# 1971 Corvette: Service Bulletin: Anti-Diesel Relay

**Subject:** Anti-Diesel Relay

**Bulletin No:** 71-T-44

**Date:** Aug. 5, 1971

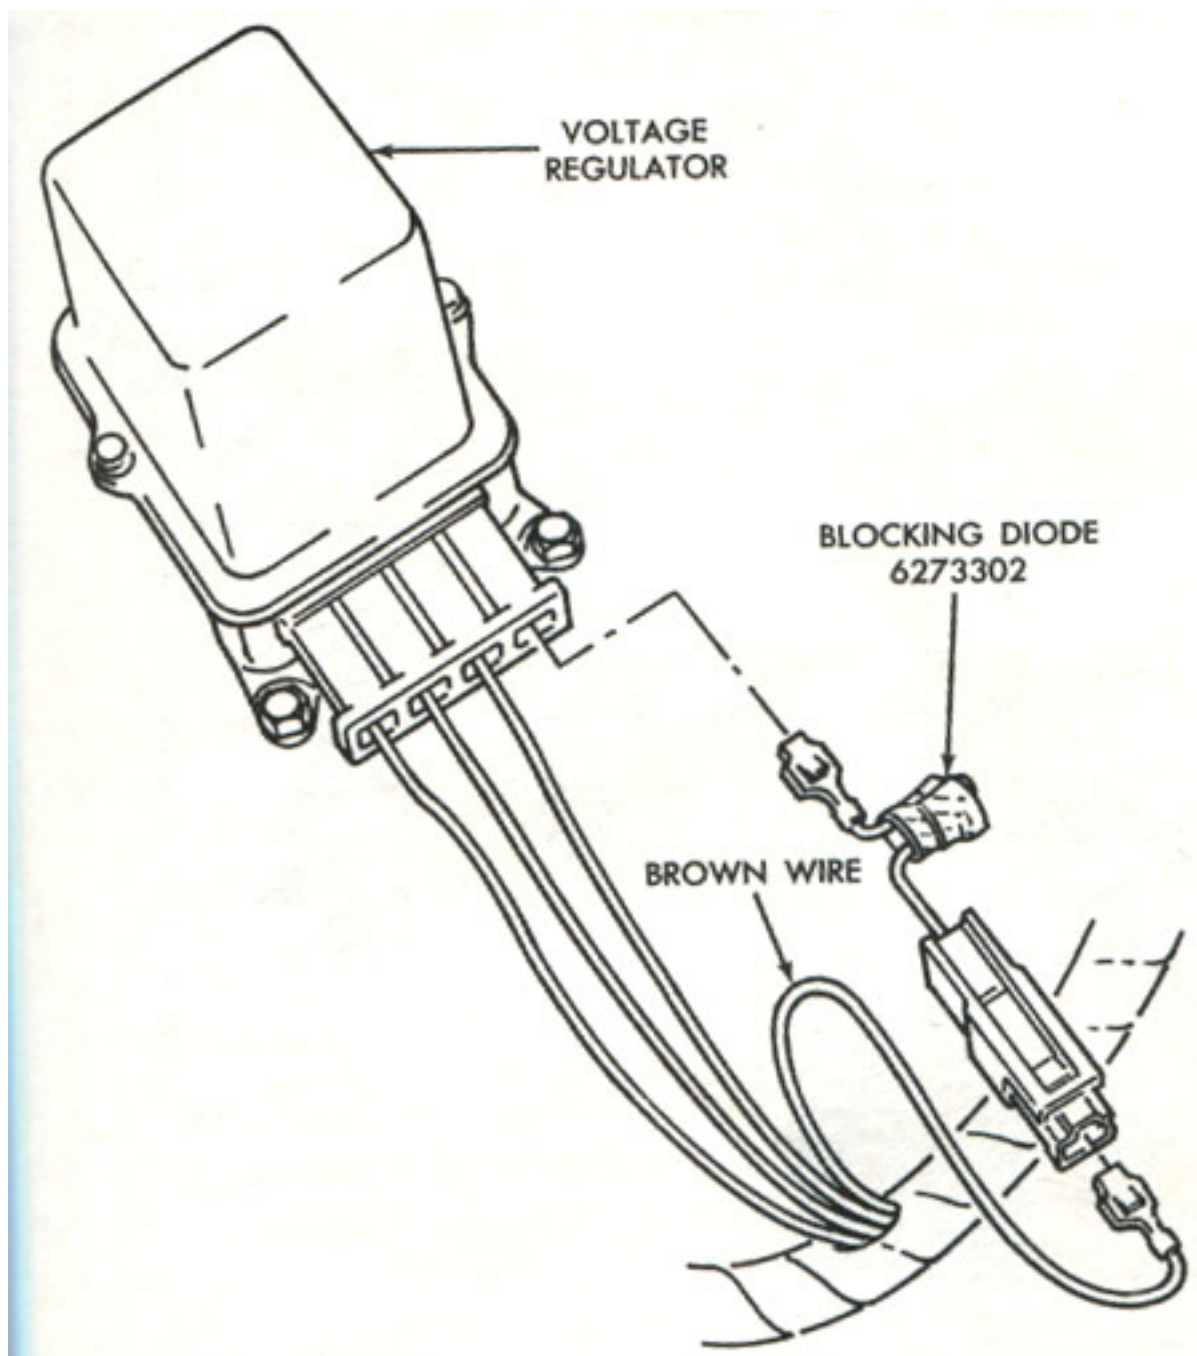
Delcotron feedback at the anti-diesel relay can result in a shorted transistor in the timing circuit of the relay. A shorted transistor will cause the anti-diesel relay to hold the air conditioning compressor clutch engaged continuously, after the engine is turned off, draining the battery.

A new anti-diesel relay, with a suppression diode across the relay coil to protect the transistor, entered production the week of April 26, 1971, at all assembly plants. Also, a blocking diode is being installed at the voltage regulator to prevent Delcotron feedback on all models except Corvette. The Corvette uses the new relay but, due to the integrated regulator, does not require the voltage regulator blocking diode.

For service on light trucks, to prevent Delcotron feedback to the anti-diesel relay, blocking diode, Part Number 6273302, should be installed at the voltage regulator as outlined under Service Procedure - Truck.

### Blocking Diode Installation

1. Disconnect wiring harness from voltage regulator.
2. Remove brown wire from the plastic connector.
3. Install the blocking diode between the voltage regulator connector and the brown wire as illustrated in Figure 1.
4. Connect harness to voltage regulator.
